TITLE: DOORS - INSPECTION OF THE INTERIOR DOOR HANDLES

This service bulletin has been revised to reflect changes in the Reason, Compliance Statement and the Accomplishment Instructions. Relevant technical changes are marked with change bars in the outside margins.

SB 52-2693, Rev. 2

Figure 1

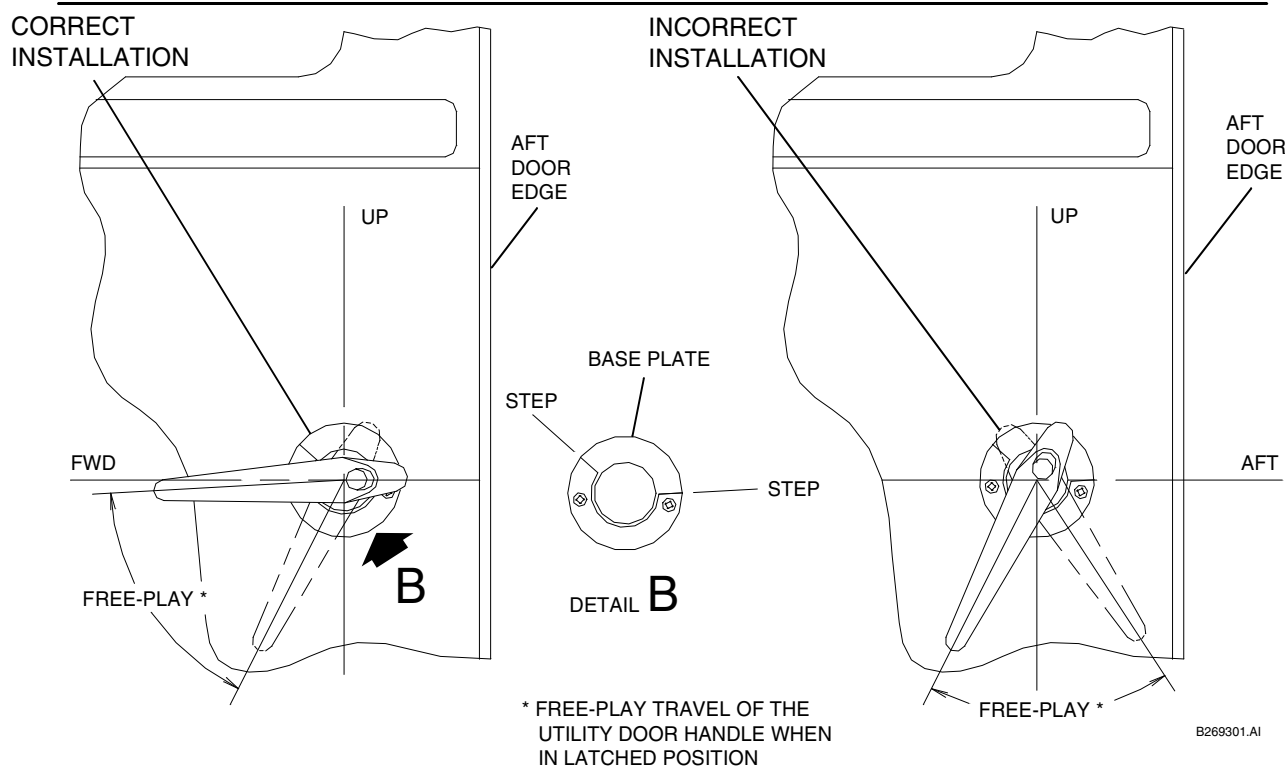
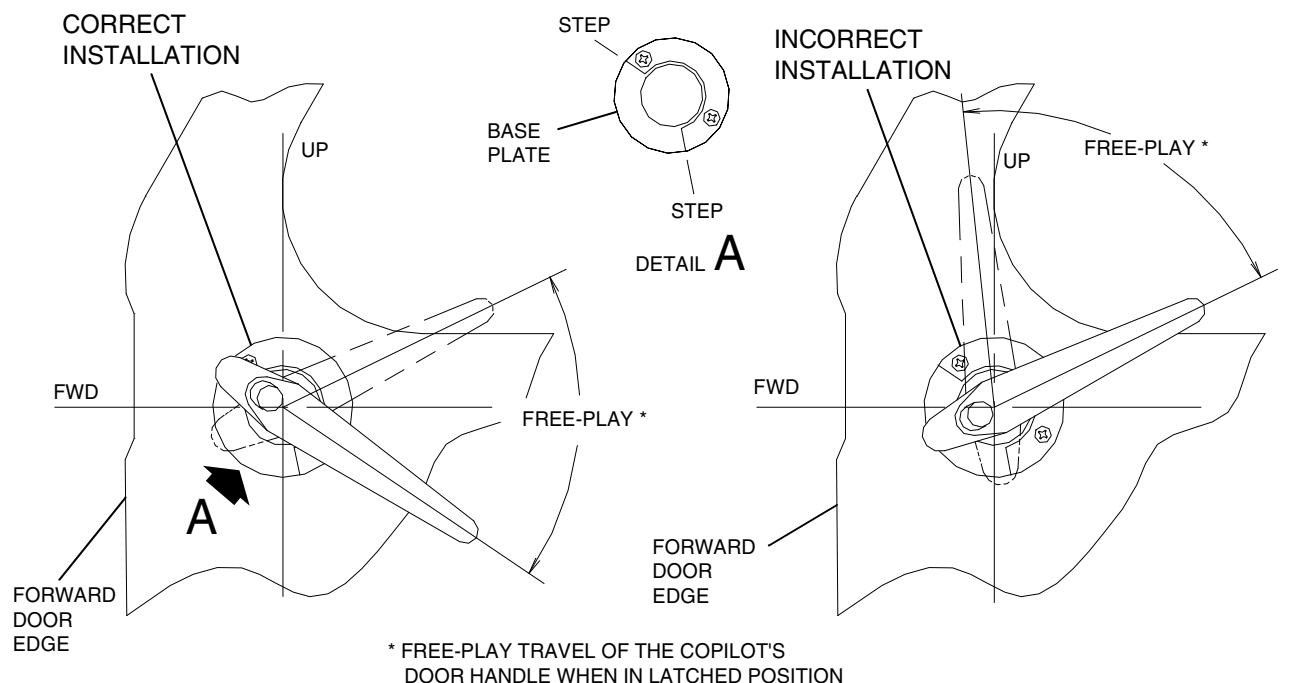
This Service Bulletin is being issued to inspect both the interior cabin door handle and the interior utility door handle for proper installation. An investigation into a report that the utility door opened without having to depress the handle lock release button has revealed that if the door handle is not properly oriented during installation, the handle lock mechanism does not restrict inadvertent unlatching of the door.

- (4) Rotate the door handle 90° clockwise, maintaining the base plate in the same position. Figure 1 illustrates the incorrect installation and correct installation of the interior door handles. (Note: Handle configuration of some airplanes may differ from what is shown in Figure 1).

- (1) Prior to removal of either interior door handles, with the handles in the open position, place a strip of masking tape next to the short end of the handle to easily indicate the correct orientation of the handle for installation.

- (2) Remove the two screws which secure the interior door handle base plate.
- (3) Slide the interior door handle from the shaft, maintaining the same orientation of the door handle with respect to the shaft.

- (5) Slide the interior door handle over the shaft and secure, using the screws removed in step (2). Check the short end handle to ensure it is aligned with the tape.

- (7) Rotate the interior door handle clockwise without depressing the handle lock release button. If the door remains latched, proceed to step (8). If the door becomes unlatched, repeat steps 1 through 6.
- (8) With the door latched, depress the handle lock release button while rotating the handle clockwise. Rotating the door handle clockwise while depressing the handle lock release button should unlatch the door.
